### PLANNING COMMISSION MEETING

A. Redevelopment at 9328 Highland Road

Request: Preliminary Site Plan Approval

RE: 9328 Highland Road- Commercial Building with Drive Thru- Preliminary Site Plan Review - 1st

**SITE PLAN**

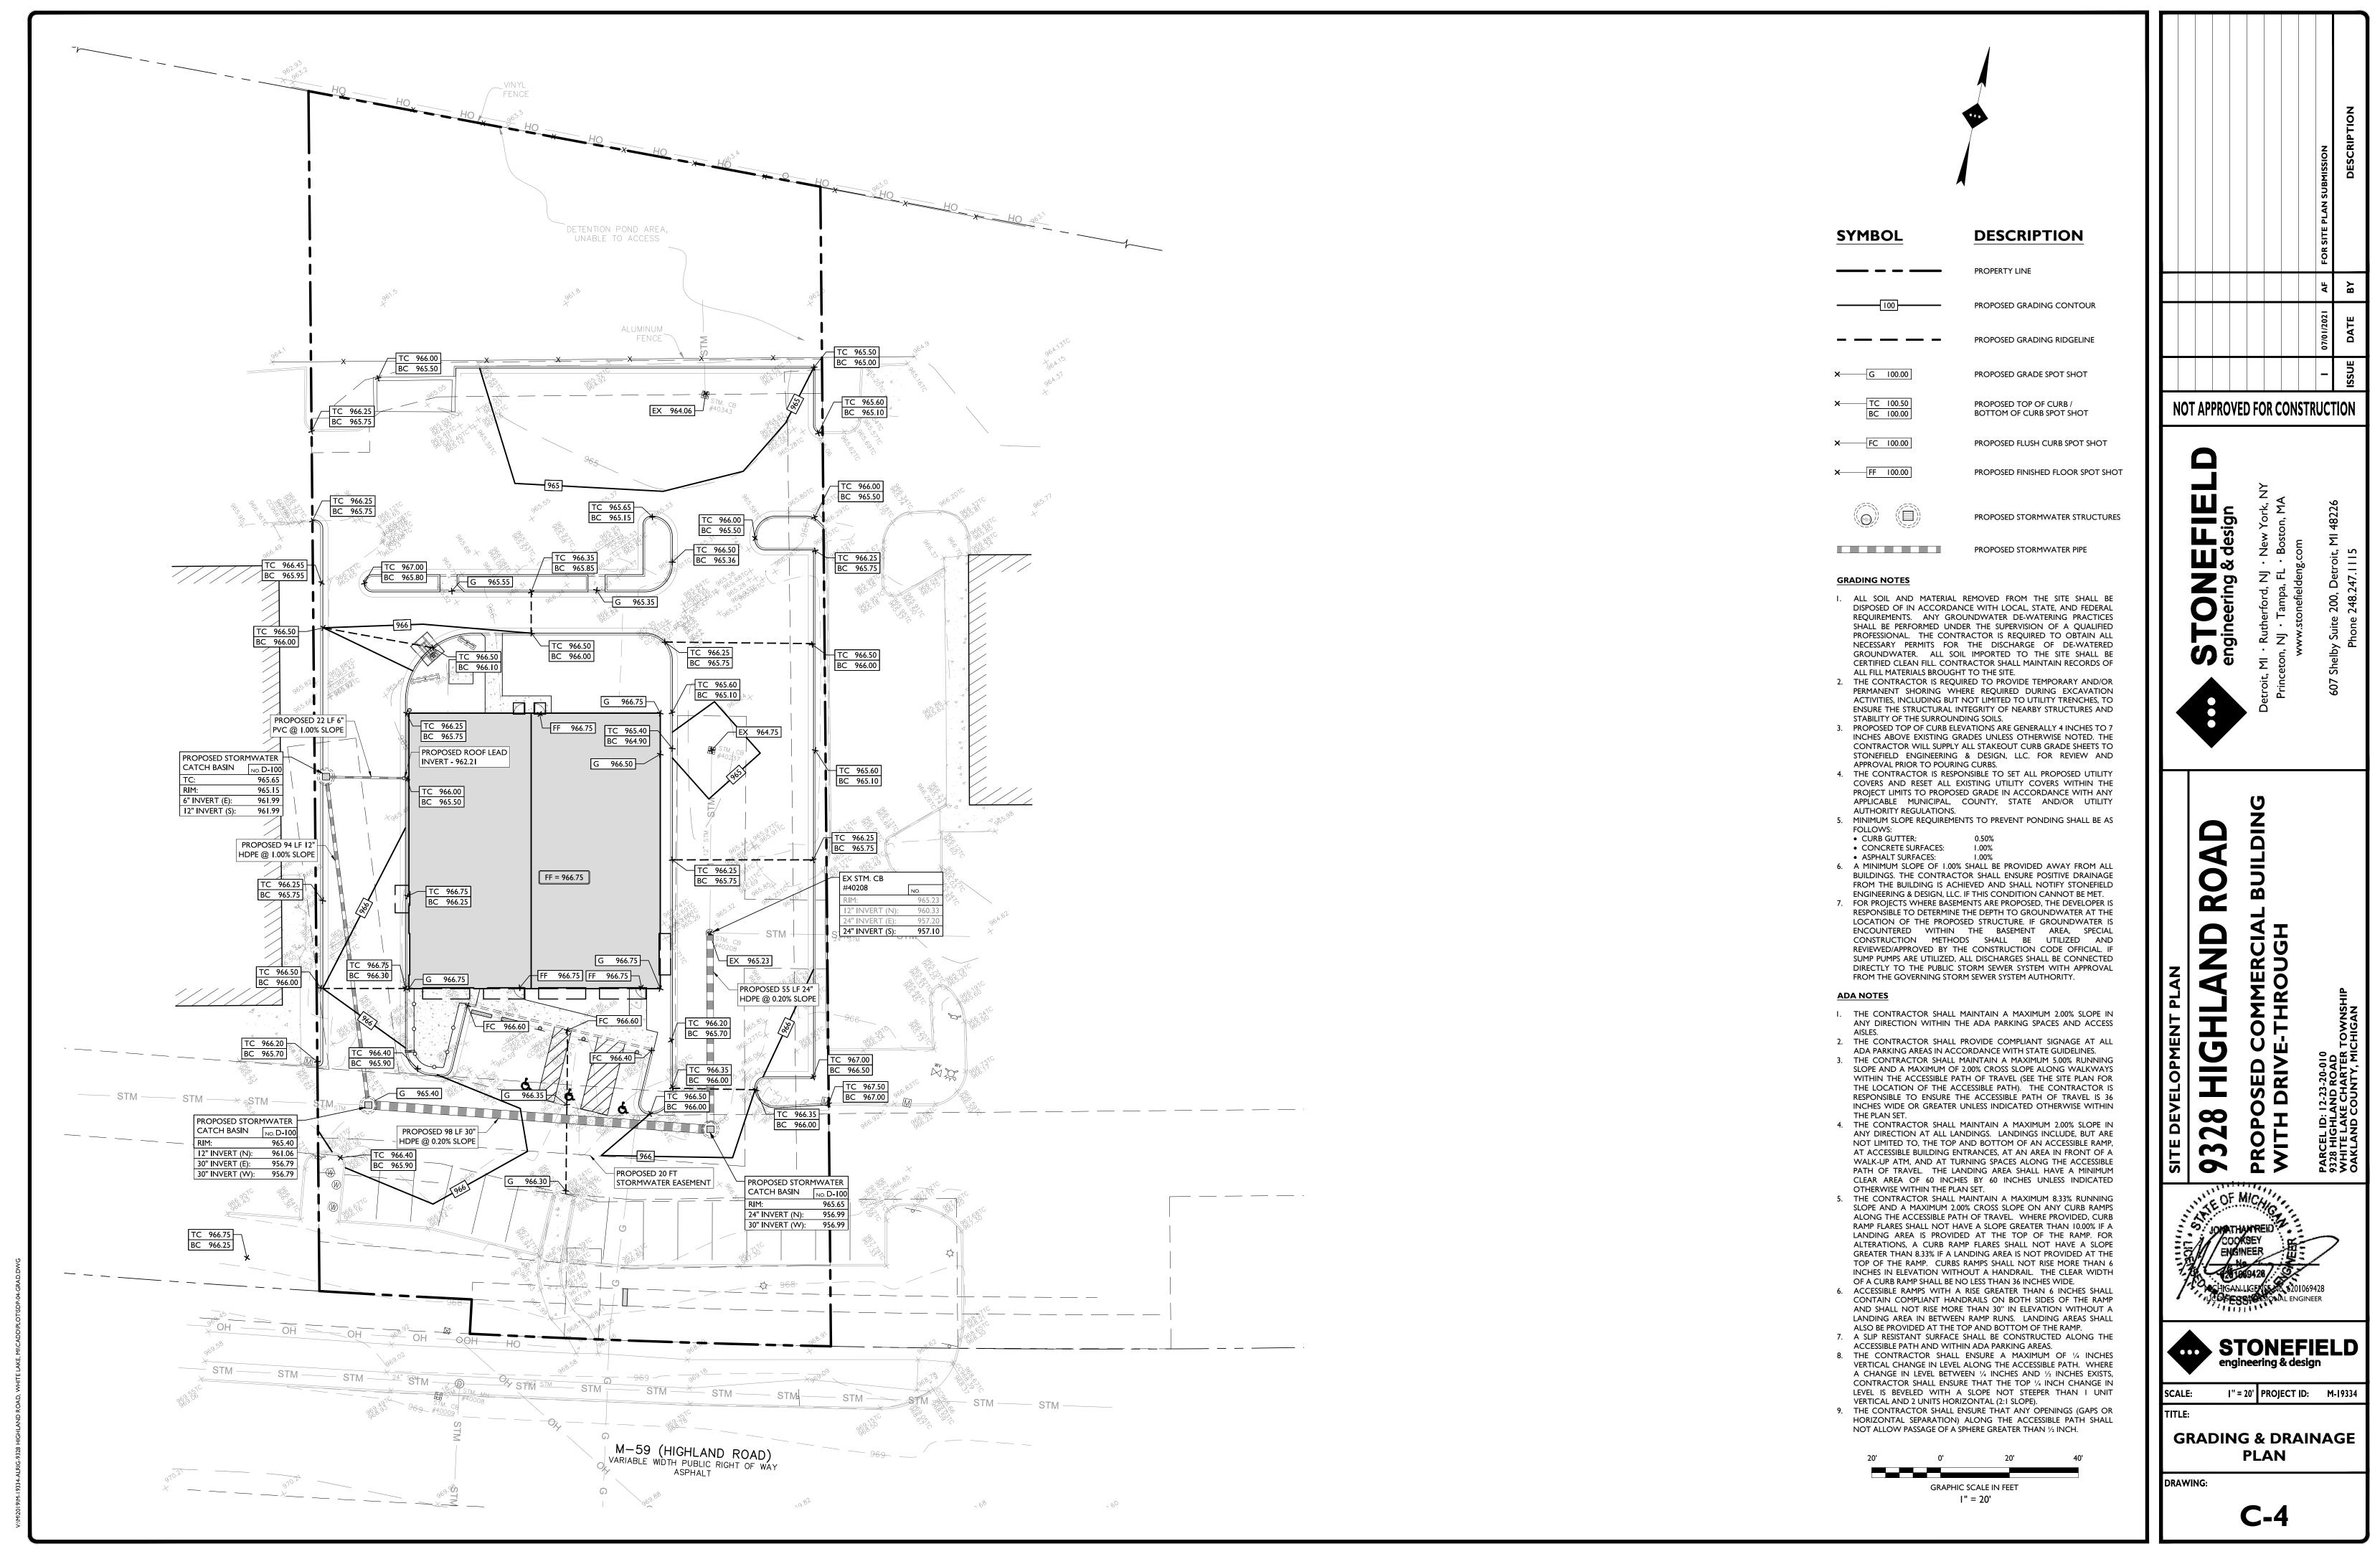
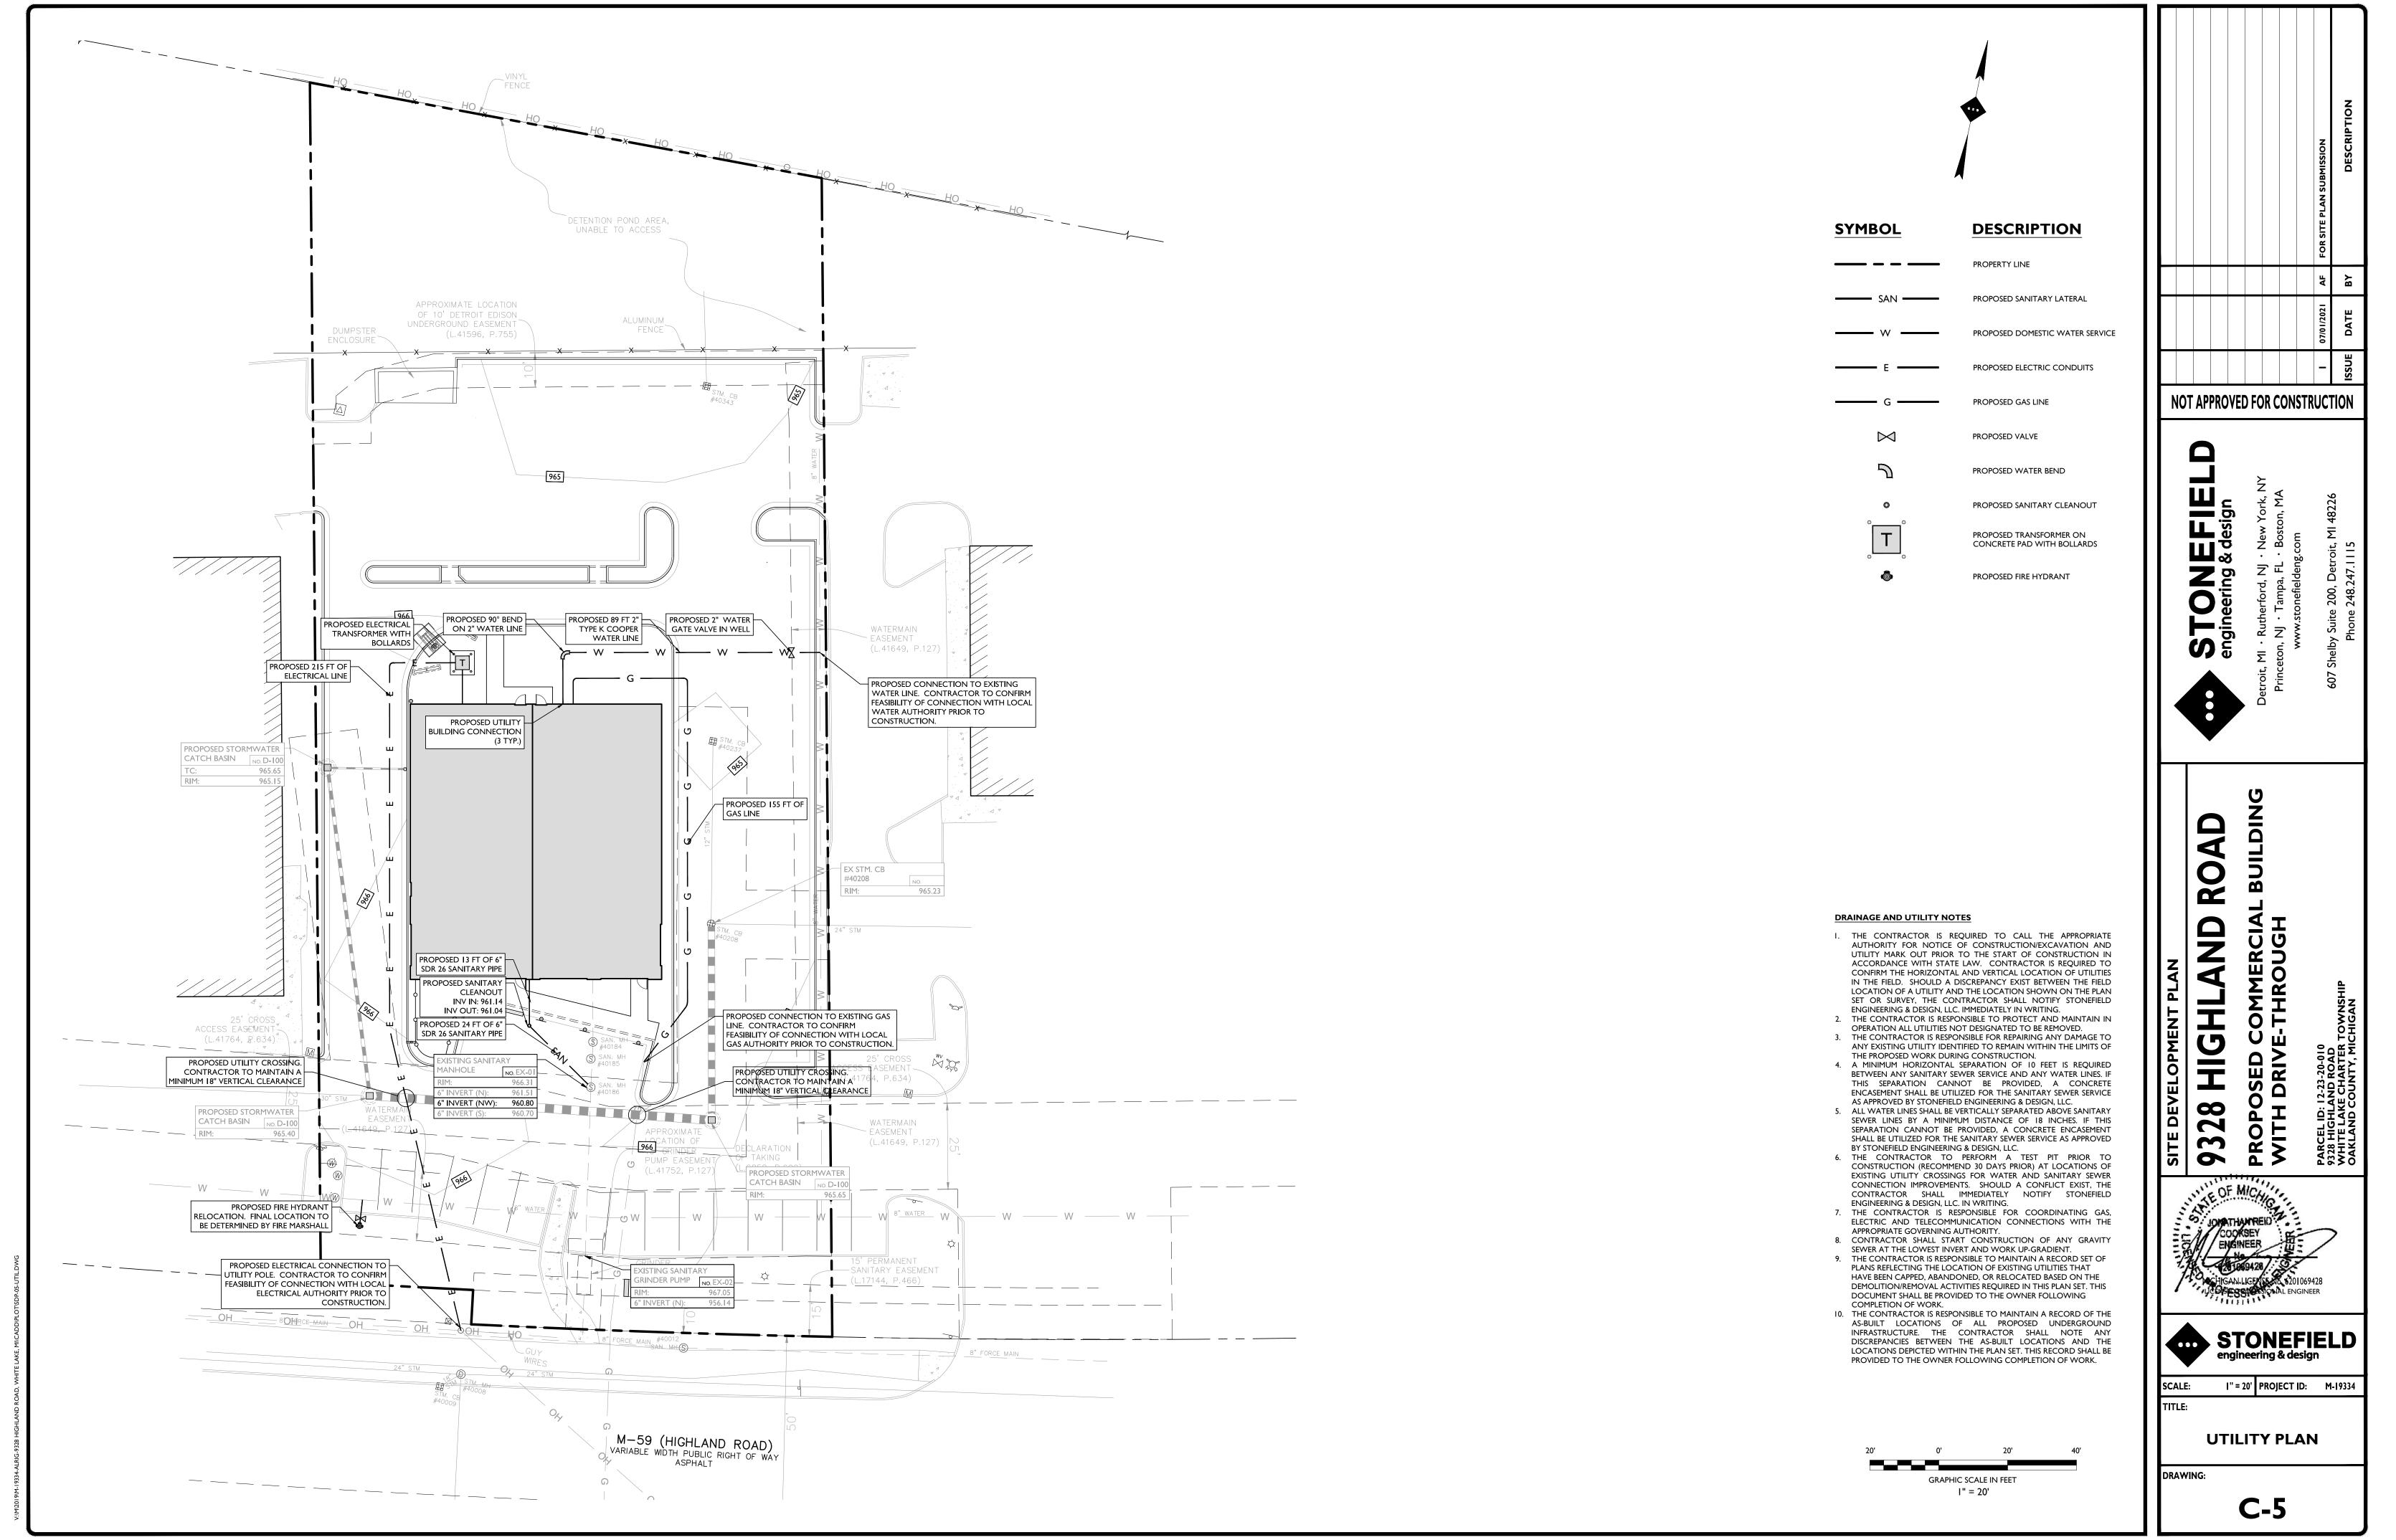
- 9. The plan appears to propose 5 foot wide sidewalk in front of the building, ordinance requires 7 foot walks to account for vehicle overhang. This may be allowable as the plans propose either bumper blocks or handicap signs in front of the spaces which would prevent overhang. We defer further comment to the Planning Department or Planning Consultant.

Circulation is two way on the east side of the site and one way on the west side (to accommodate the drive thru traffic). No loading spaces are proposed, although the Zoning Ordinance requires one, 10' by 50' space with 15' height clearance. The applicant has indicated that loading and unloading will be done off hours. **The Planning Commission should determine if this is appropriate.**

- 6. **Pedestrian Circulation.** Per Section 5.21 of the Zoning Ordinance, an eight (8) foot wide public sidewalk is required along Highland Road. Currently, there is a pathway along the frontage of the property. The applicant should indicate the width of this pathway on the final site plan.
